Construction Drawings for Meridian Rd./Bent Grass Meadows Dr. Intersection Improvements

Bent Grass Metro District, County of El Paso, State of Colorado

**TRAFFIC CONTROL
 SIGNAL PLANS**
Bent Grass Meadows Dr./Meridian Rd.

TRAFFIC SIGNAL DESIGN
Bent Grass Meadows Dr./Meridian Rd.

SIGNS

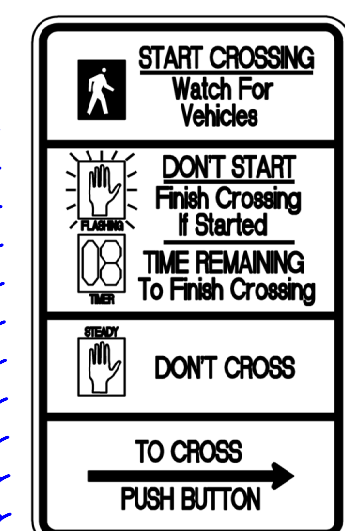
It's not a good idea to provide partial pedestrian infrastructure (without ramps or crossing)

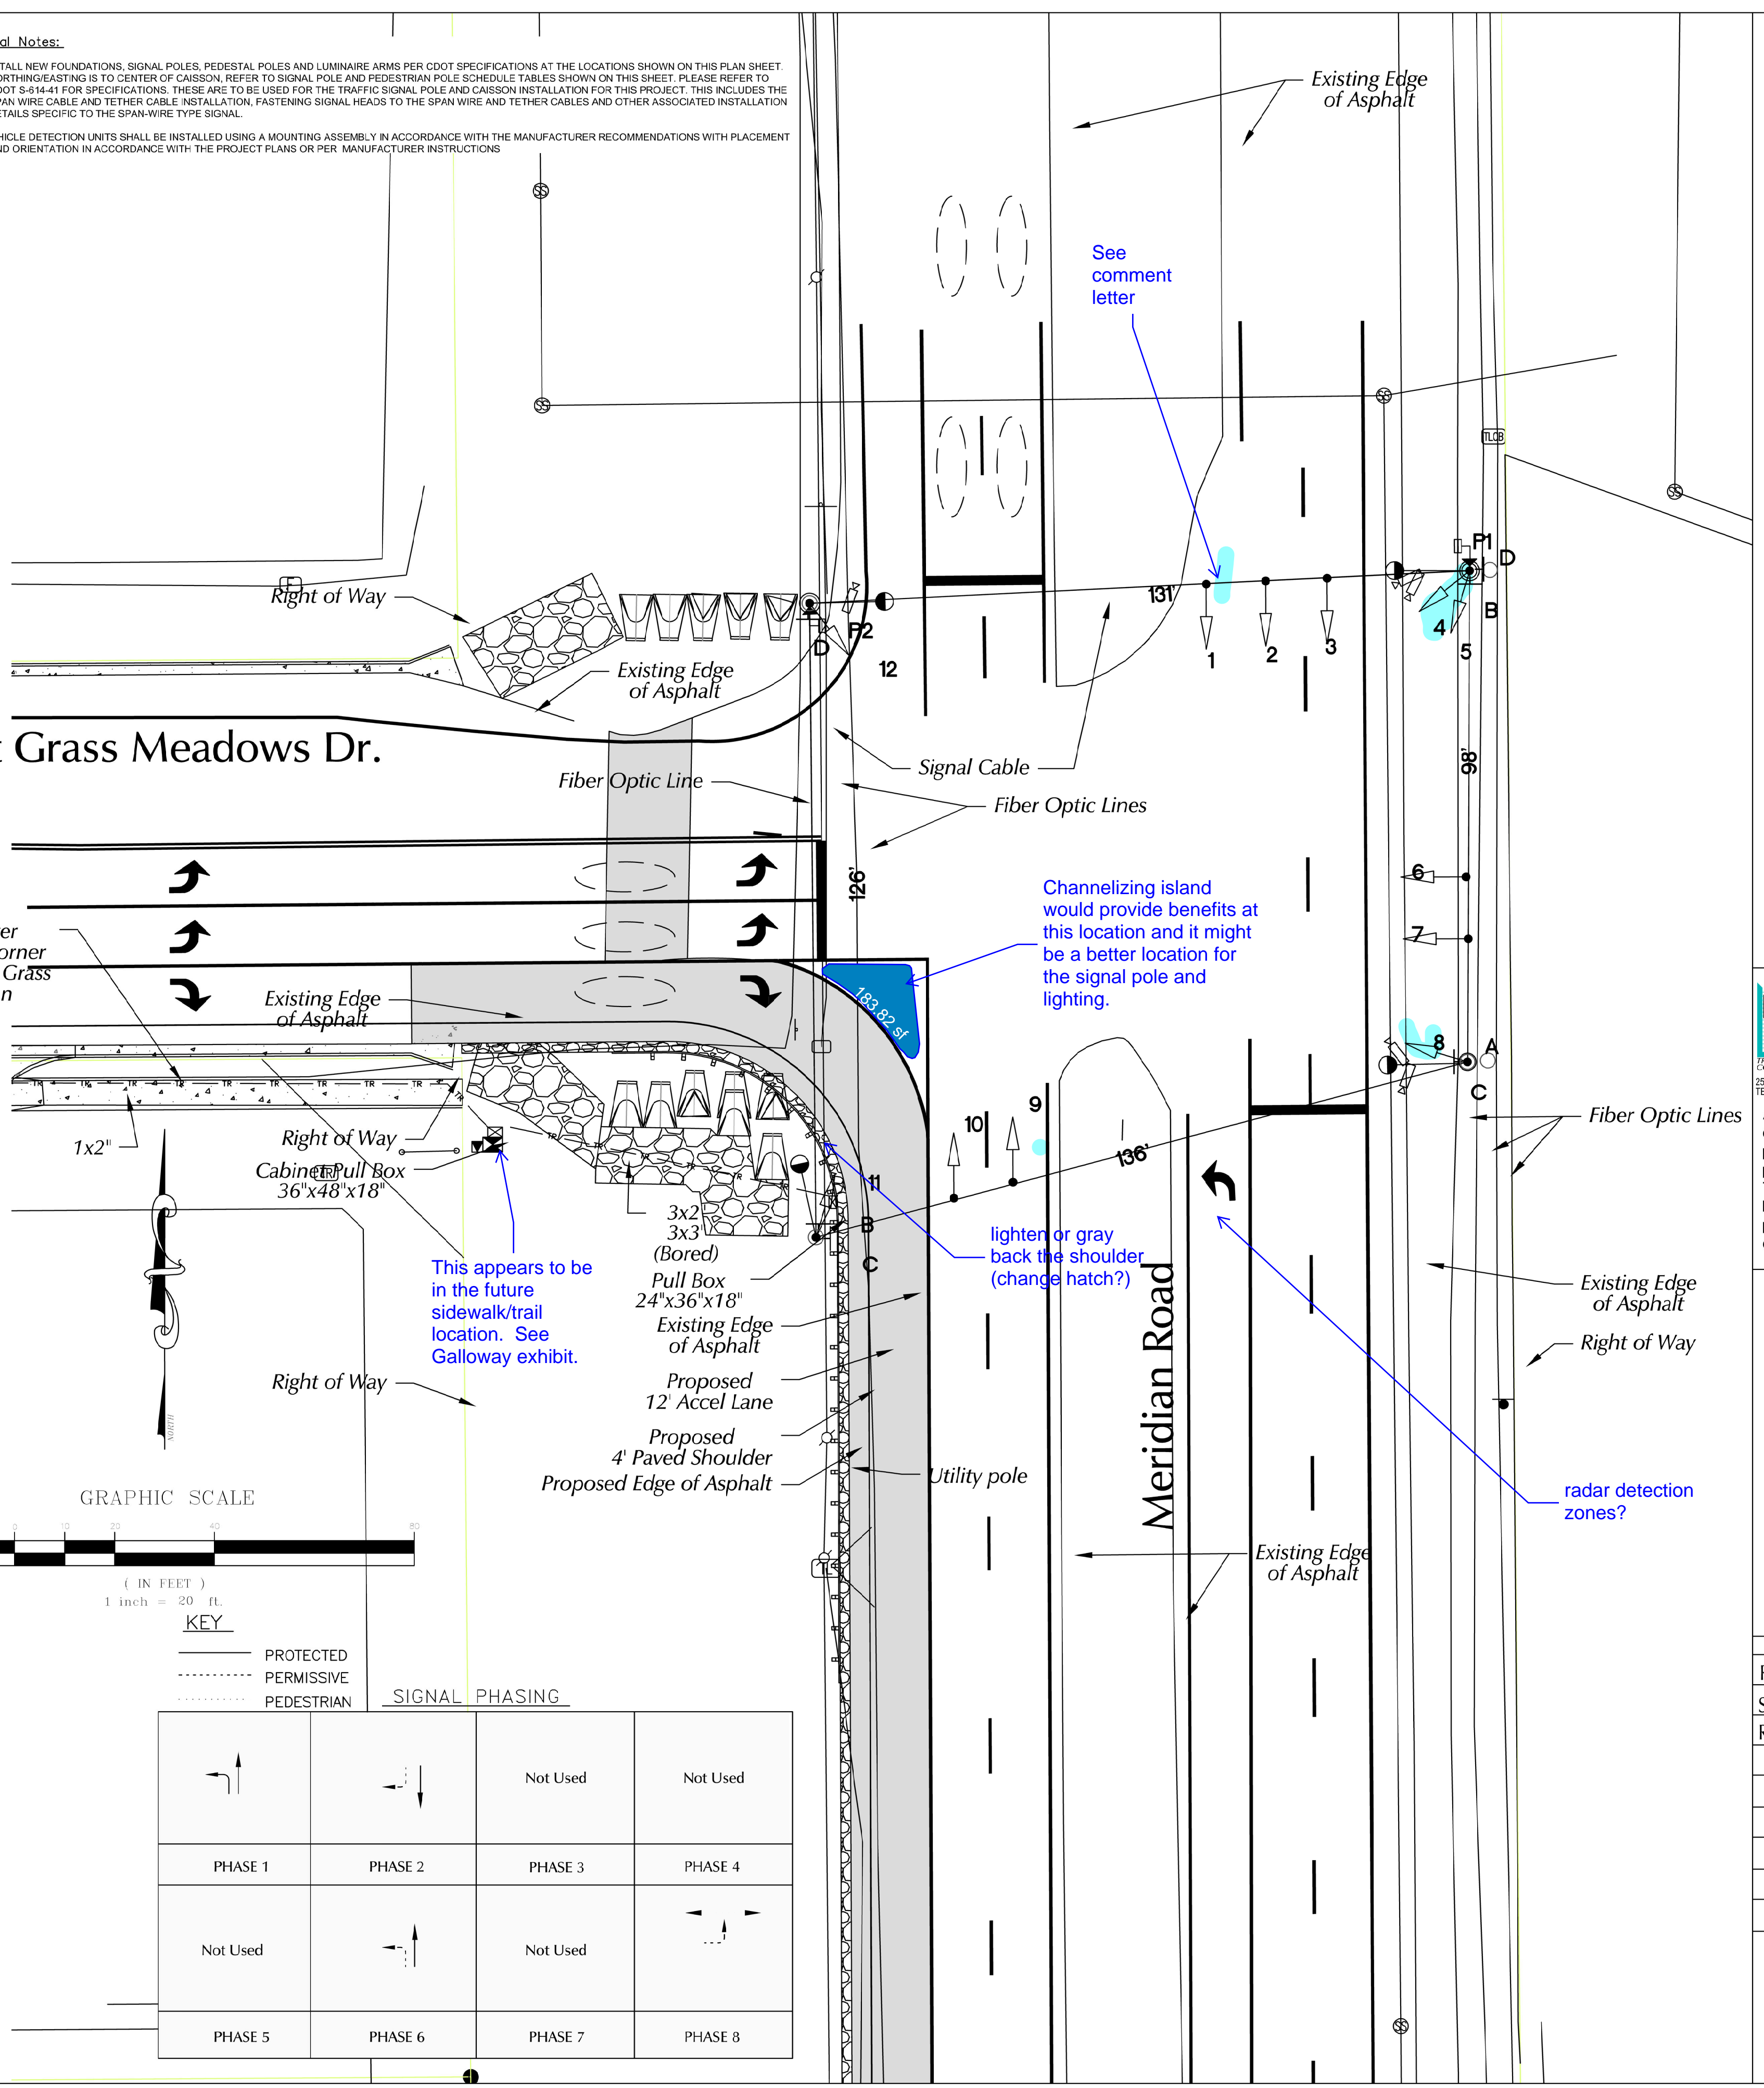
See comment letter

Channelizing island would provide benefits at this location and it might be a better location for the signal pole and lighting.

lighter or gray back the shoulder (change hatch?)

radar detection zones?
